ARCHITECTURAL REVIEW BOARD REGULAR MEETING AGENDA

June 11, 2026

STAFF REPORT

DATE: June 11, 2026
TO: Architectural Review Board
FROM: Renee Burton, Division Director of Planning
RE: Certificate of Appropriateness PZ25-00583, filed by Justin Williams, for the installation of a new roof at Parcel 20119 (507 Holbrook Avenue).

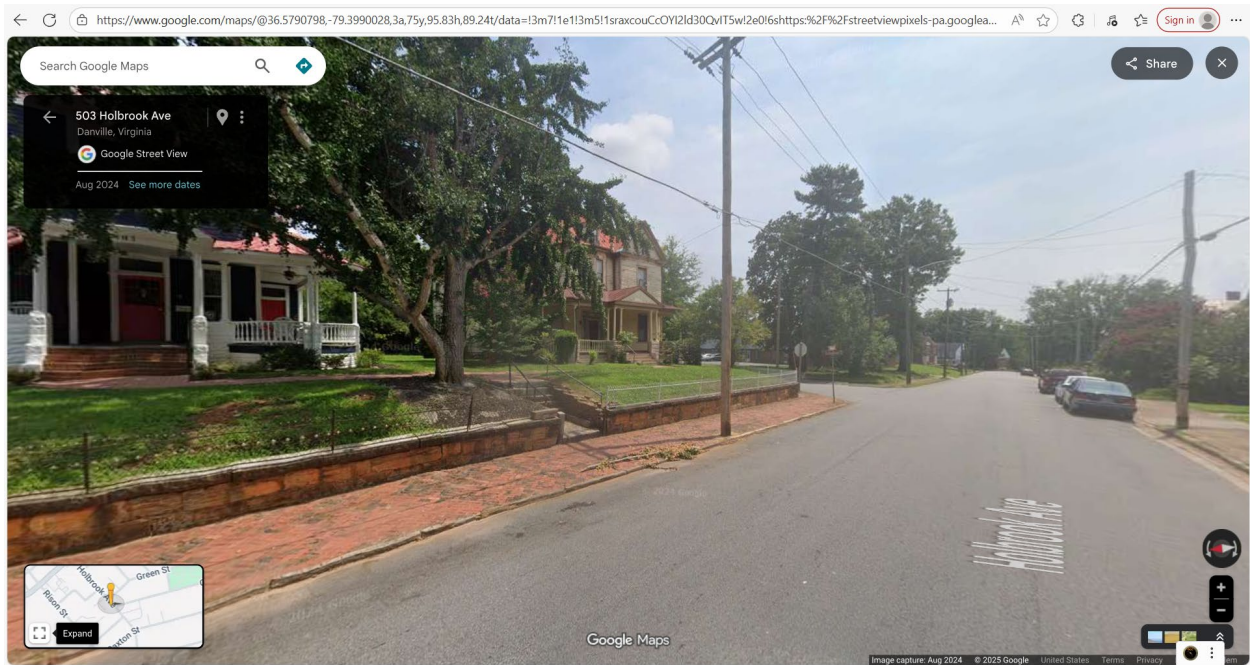
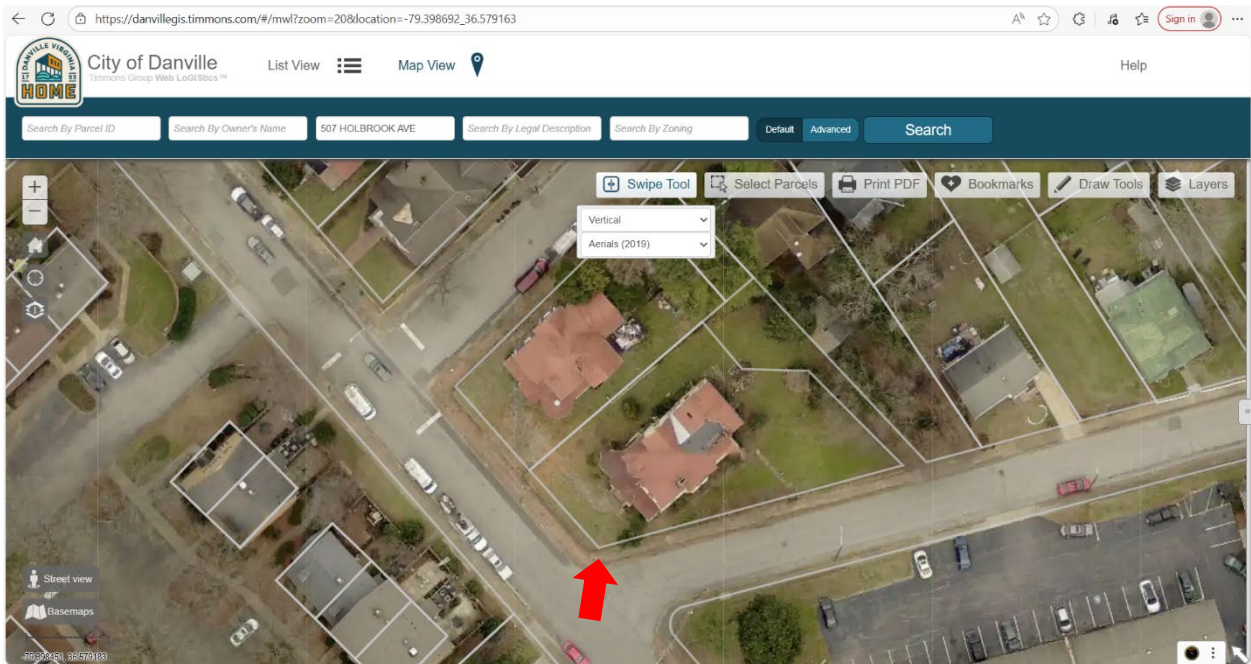
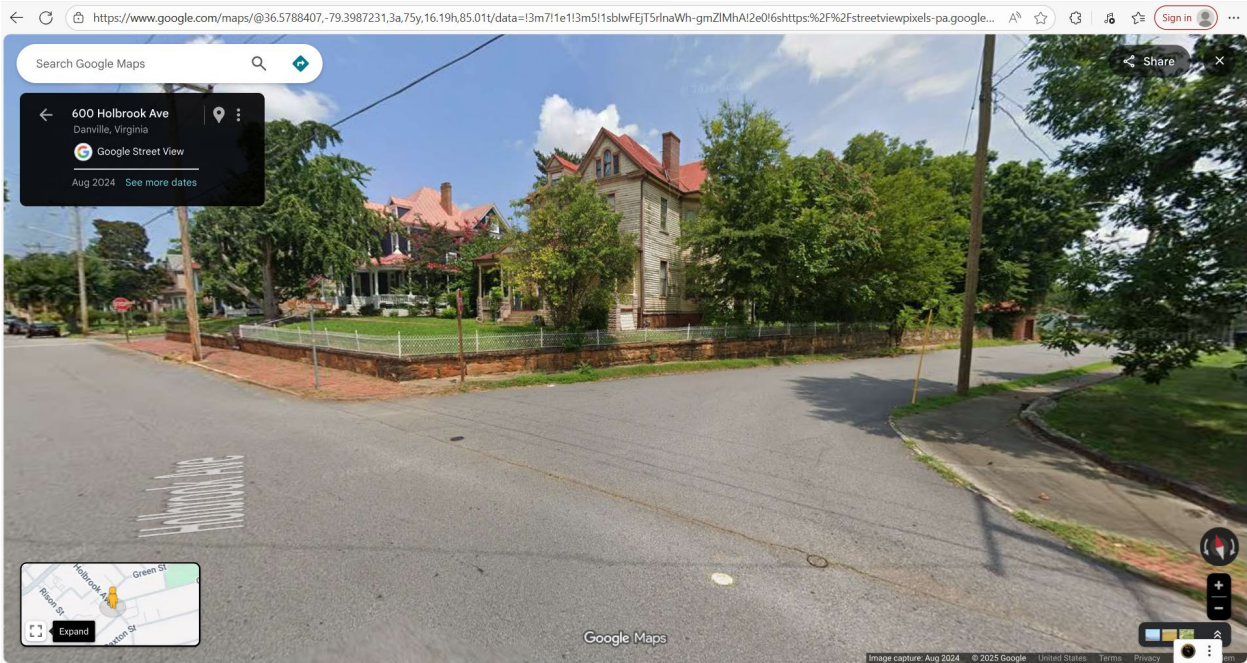
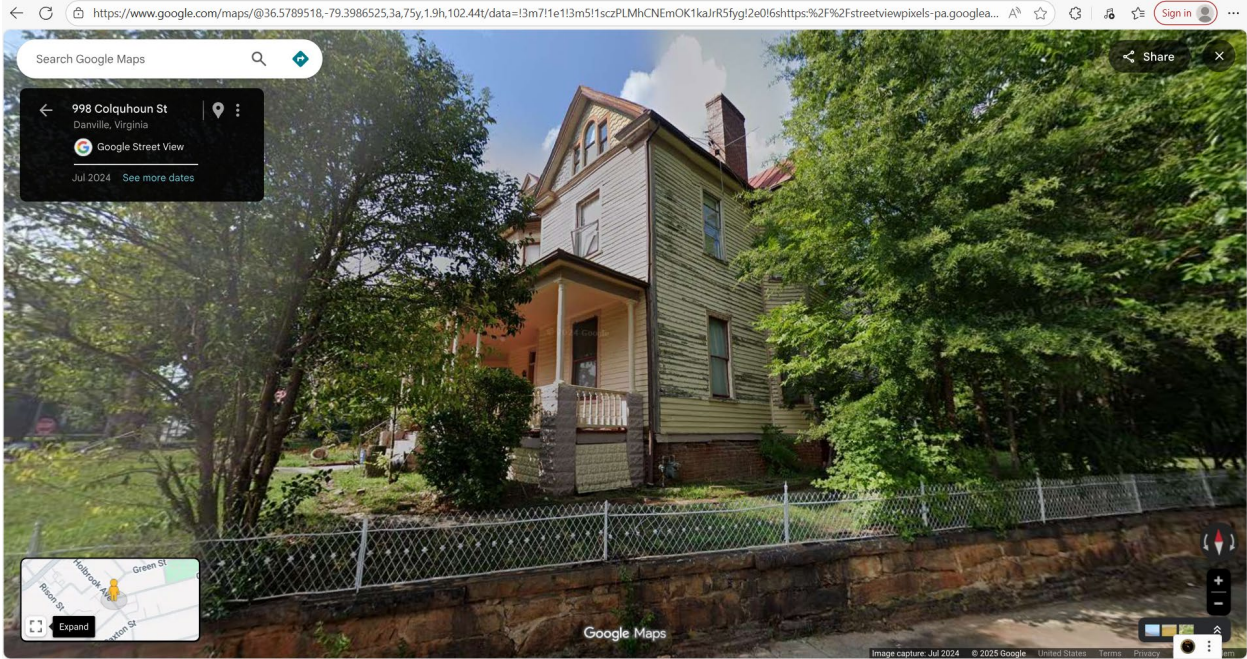
The application requests approval of installation of a new roof using 29-gauge painted steel in charcoal grey. As the thinnest roofing material available, this type of roofing is often reserved for sheds, agricultural buildings, and other accessory structures due to its lightweight and budget-friendly qualities. This roofing material works best in mild climates with little severe weather, as heavy storms can easily dent it. Planning staff has concerns about the quality of this material for a residential structure and its compatibility with the historic nature of the neighborhood. Contractors recommend 24-gauge metal for long-lasting residential roofs (40–50 years) because its superior rigidity provides better dent resistance and wind protection.

Planning staff recommends denial of Certificate of Appropriateness PZ25-00583, filed by Justin Williams, for the installation of a new roof at Parcel 20119 (507 Holbrook Avenue) due to the quality and compatibility of the proposed material. It is recommended the applicant resubmit his application with a 24-gauge or higher material.
